Appendix A: Staff Confirmatory Calculations

The U.S. Nuclear Regulatory Commission (NRC) staff performed several confirmatory calculations to verify the numerical solution technique for several component models. The staff selected the Proportional Integrating Proportional (PIP), the Proportional Derivative Proportional (PDP), the Physical Derivative (DERIV), and the first order low pass filter (LOWP1) components. The confirmatory calculations compared the SAFIR numerical solution to the analytical solution for a given set of input and component parameters. The purpose of these confirmatory calculations is to verify the validity of the numerical solution technique for a wide scope of transfer functions.

Figure A-1 Confirmatory calculation for PIP component

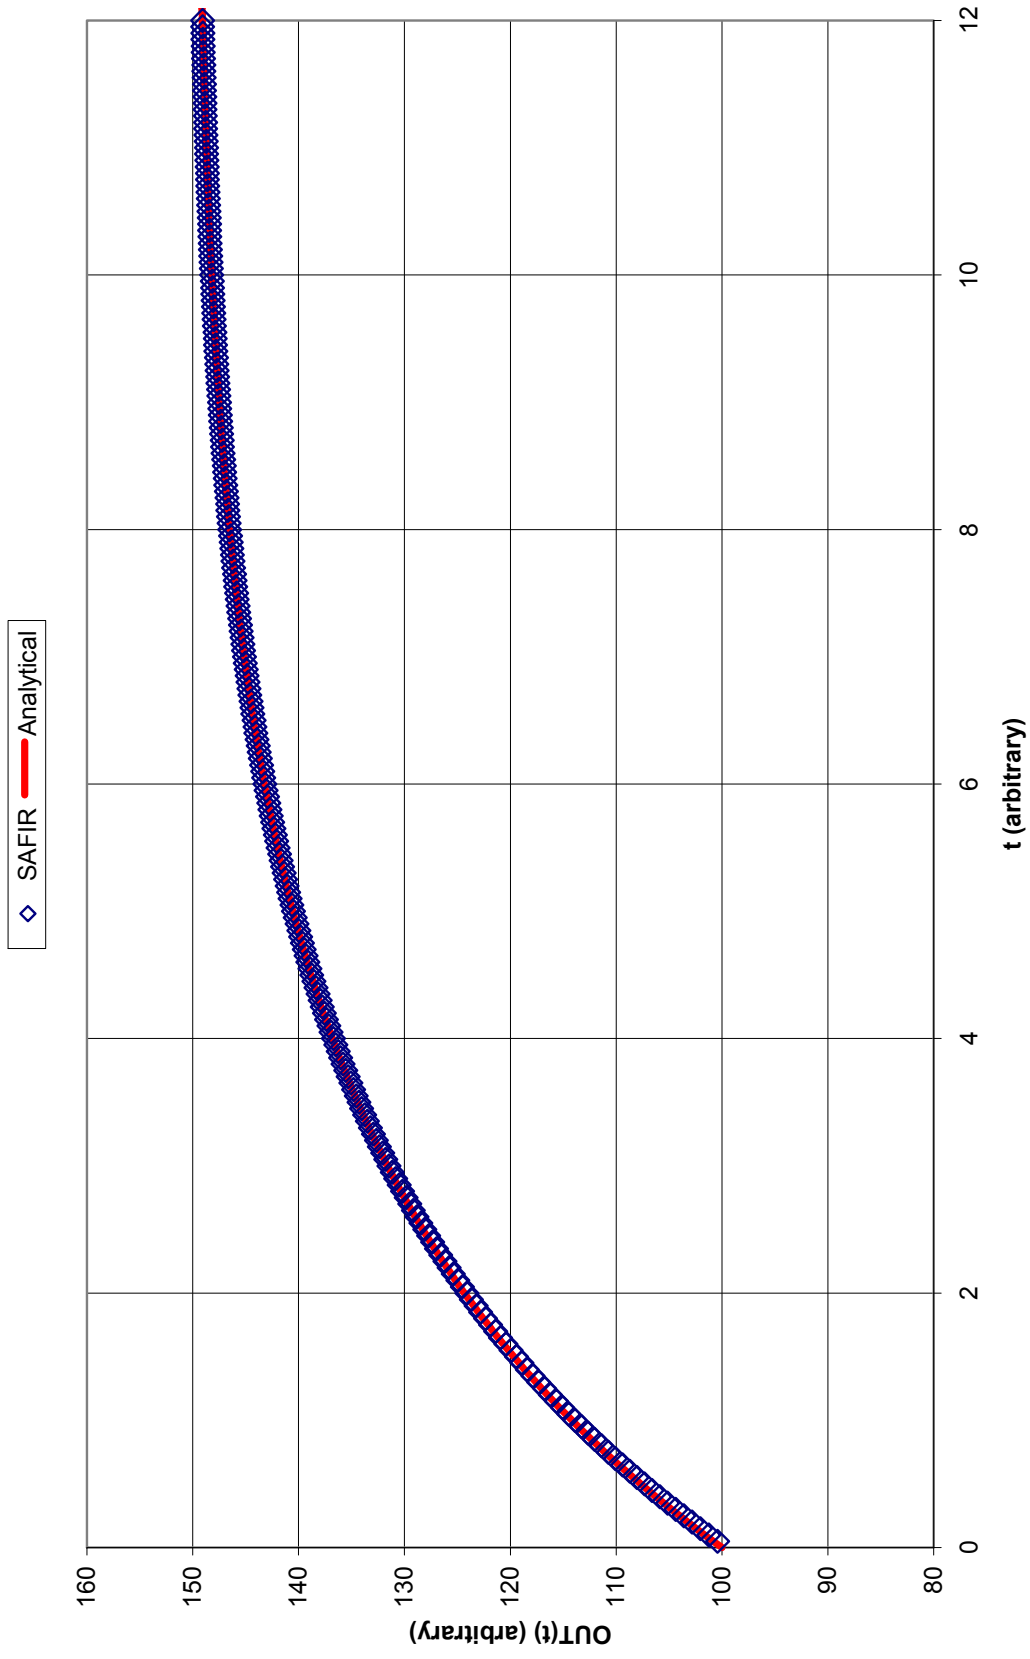
Figure A-1 illustrates the comparison between the SAIFR numerical solution and the analytical solution. The agreement is excellent and in keeping with the degree of accuracy depicted for the Proportional Integrating controller verification presented in Section 4 of Supplement 3.

Figure A-2 Confirmatory calculation for PDP component

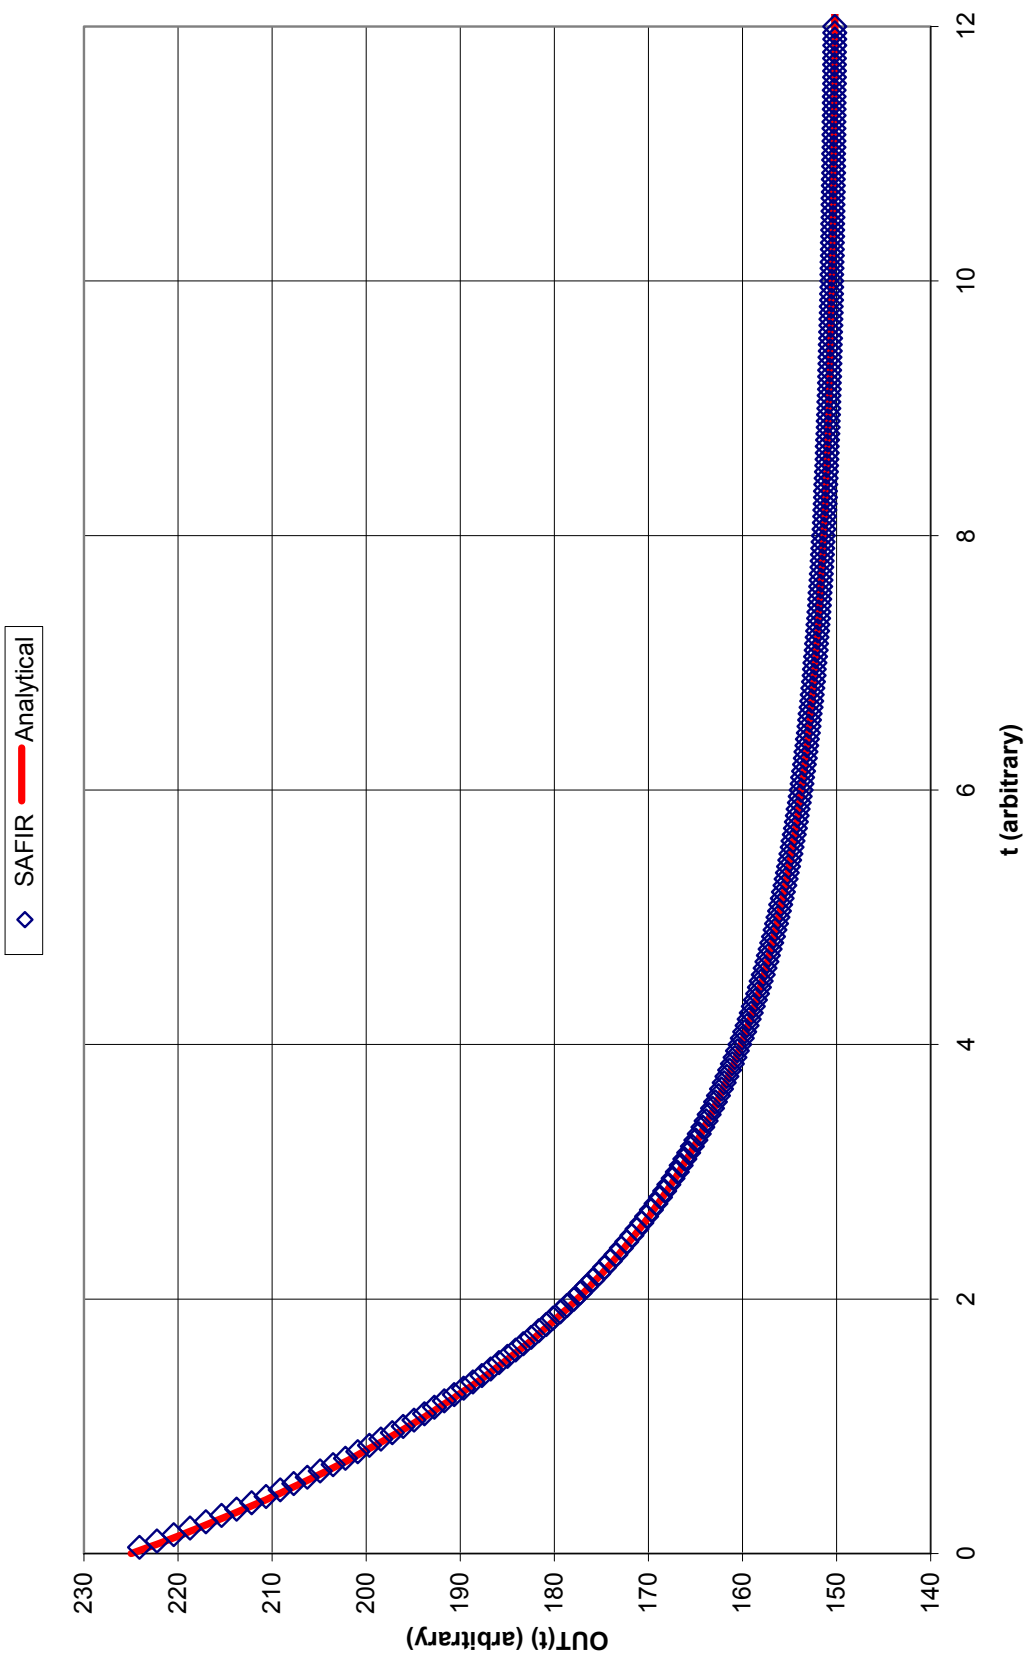
Figure A-2 illustrates the comparison between the SAIFR numerical solution and the analytical solution. The agreement is excellent and in keeping with the degree of accuracy depicted for the Proportional Integrating controller verification presented in Section 4 of Supplement 3.

Figure A-3 Confirmatory calculation for DERIV component

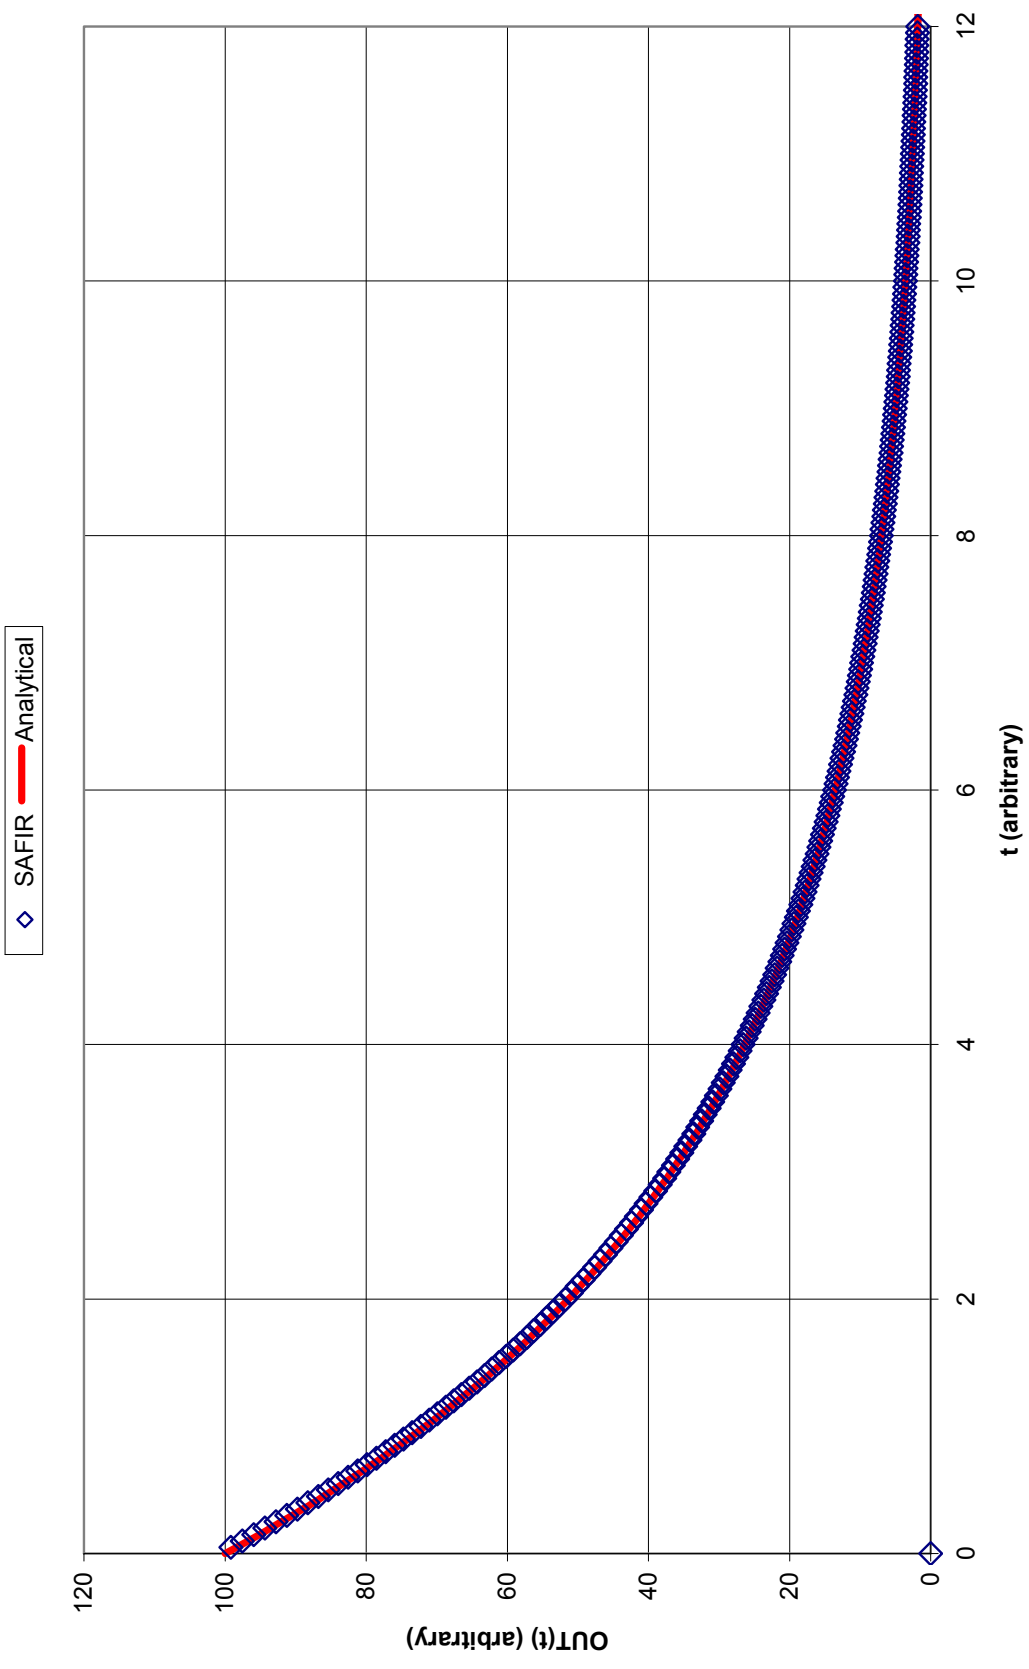
Figure A-3 illustrates the comparison between the SAIFR numerical solution and the analytical solution. The agreement is excellent and in keeping with the degree of accuracy depicted for the Proportional Integrating controller verification presented in Section 4 of Supplement 3.

Figure A-4 Confirmatory calculation for LOWP1 component

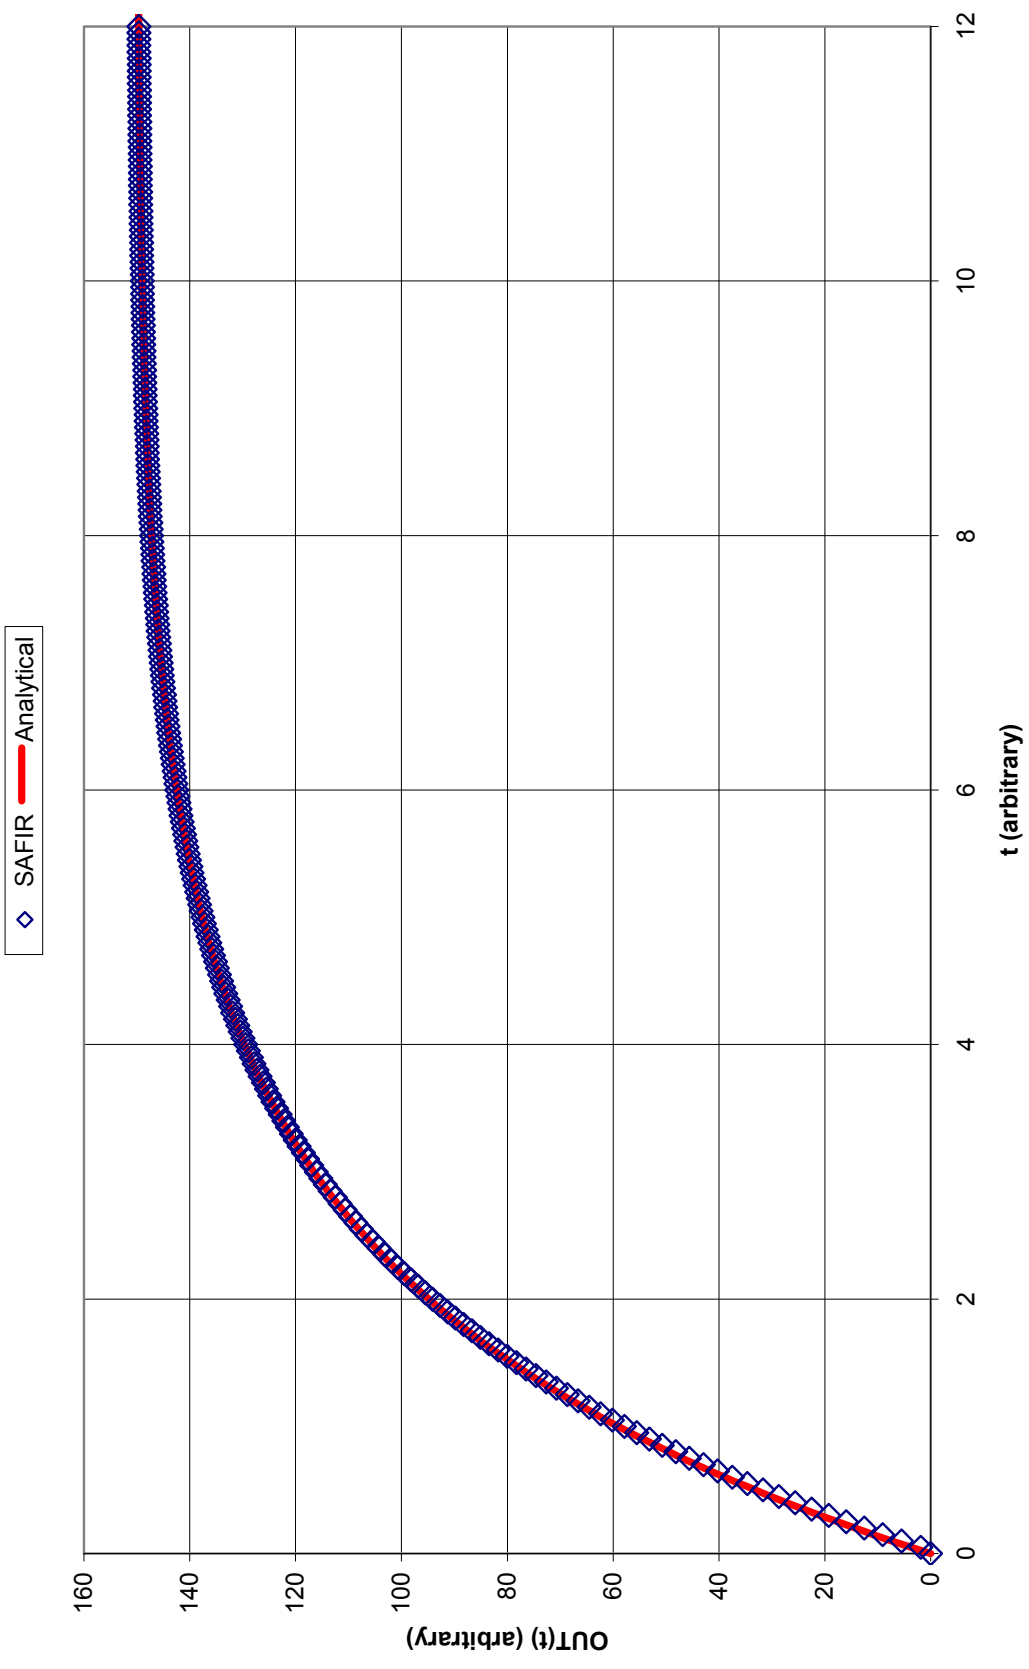
Figure A-4 illustrates the comparison between the SAIFR numerical solution and the analytical solution. The agreement is excellent and in keeping with the degree of accuracy depicted for the Proportional Integrating controller verification presented in Section 4 of Supplement 3.
